City of Detroit  
Inter-Departmental Communication

**RE:** Petition No.338  
Requested Encroachment Into Woodward At 1241 Woodward (With Outdoor Seating) Bound By Woodward, State, Griswold, And Grand River

**NOTICE OF PROPOSED CHANGE IN PROPERTY**

REQUEST ENCROACHMENT  
 INTO WOODWARD  
 AT 1241 WOODWARD AVE.  
 (With Outdoor Seating)

DRWG. NO. X 338

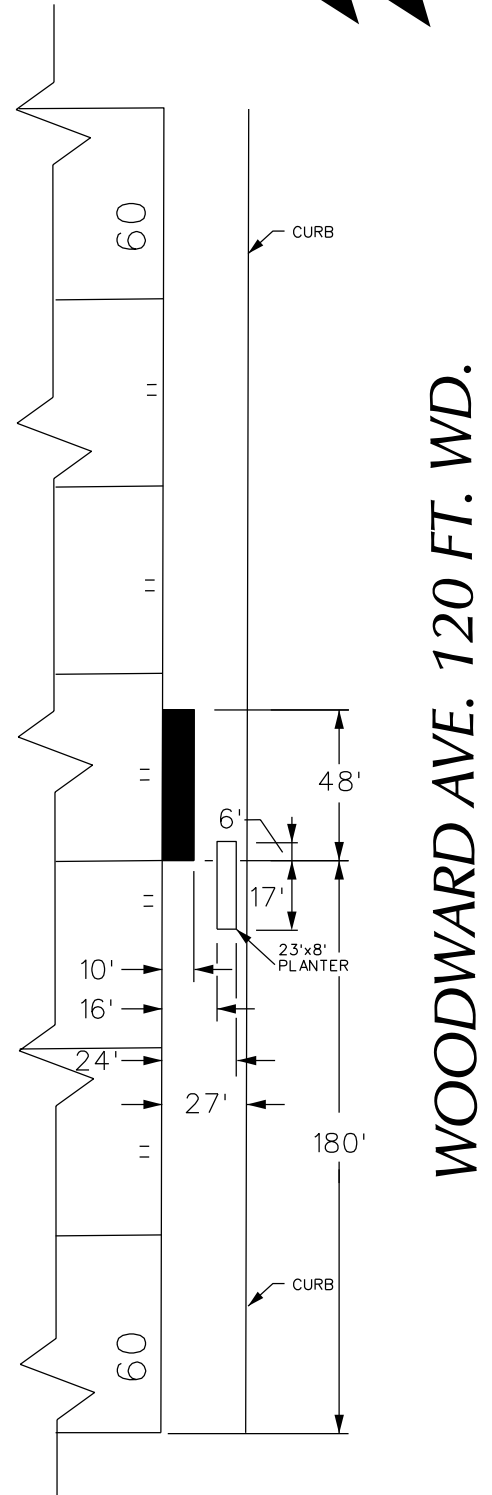
- DWSD has no objections to the requested encroachments provided that the attached Provisions for Encroachment are strictly followed.

2. DWSD requires a vertical clearance of 18 feet above grade for maintenance excess and repair.
3. All construction performed under this petition shall not be commenced until after five (5) days written notice to DWSD. Seventy-two (72) hours notice shall also be provided in accordance with P.A. 53 1974, as amended, utilizing the MISS DIG one call system.
